Addendum No. 2

Subject: John M. Patterson Elementary School
2022 Classroom Modernization
SDP Contract Nos. 2022-010-G, 2022-010-P, 2022-010-E

Location: John M. Patterson Elementary School
7001 Buist Avenue
Philadelphia PA 19142

This Addendum No. 2, dated FEBRUARY 18, 2022, shall modify and become part of the proposed Contract Documents of the work of this project. Any items not mentioned herein, or affected by, shall be performed strictly in accordance with the original Contract Documents, unless modified by prior addenda.

1 ELECTRICAL SECOND FLOOR LIGHTING NEW WORK PLAN
SCALE: 1/8" = 1'-0"

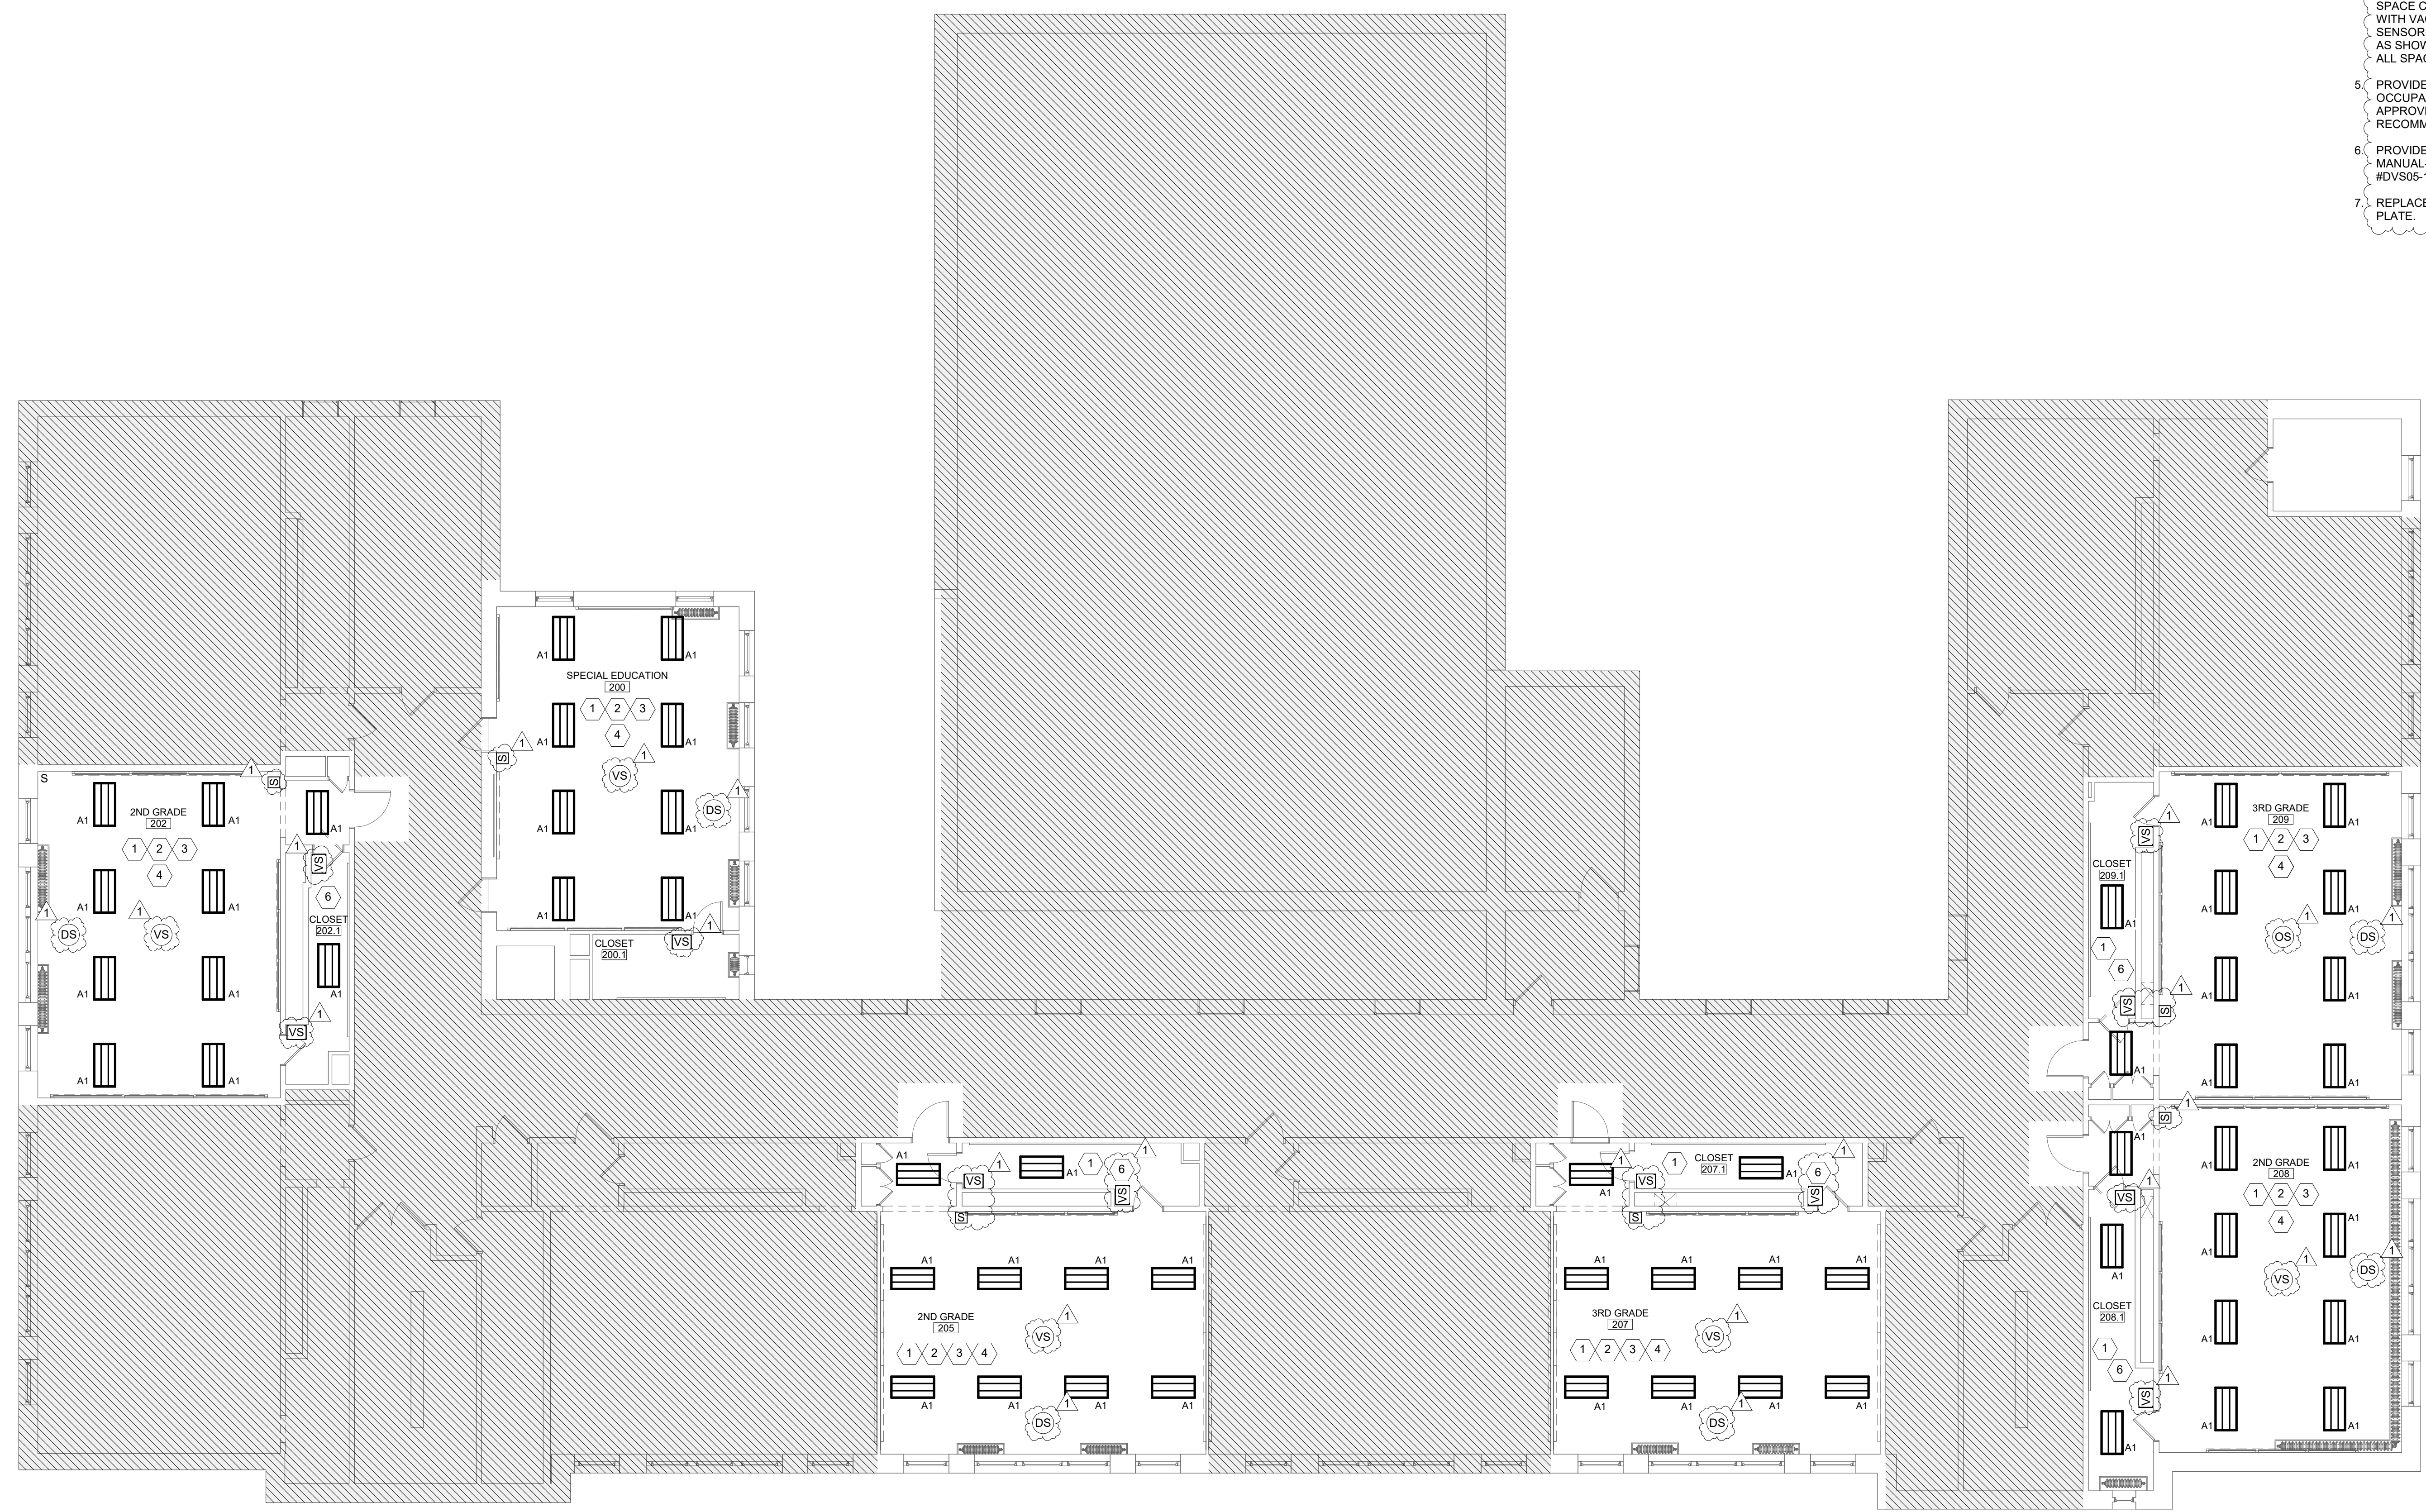
15. **Question:** Drawings E200, E201, E202, E203 sheet new work keynote #1 calls for dimming lighting controls in the classrooms but the note has very little detail on design requirements. The floor plans show nothing in terms of design for the lighting controls (control layout, zoning, basis of design part numbers etc.). The floor plans conflict with keynote #1 and show single pole switches which do not dim. Why was a design not provided with basis of design control part numbers like all other typical SDP projects? If no design will be provided, please answer questions below.

30. **Question:** New work keynote 2 on E201/E202/E203/E200 states to provide new ceiling grid, and new work keynote 4 states to provide new tiles as needed to accept new lighting layout. Please confirm new ceiling grid and tiles are to be provided by the GC contract.

Response: Refer to revised E200 series drawings attached.

Response: New tile and grid to be provided by GC in main building – refer to architectural A200 drawings for scope of grid and tiles replacement. Refer to revised keynote 2 on E201, E202, E203 drawings.
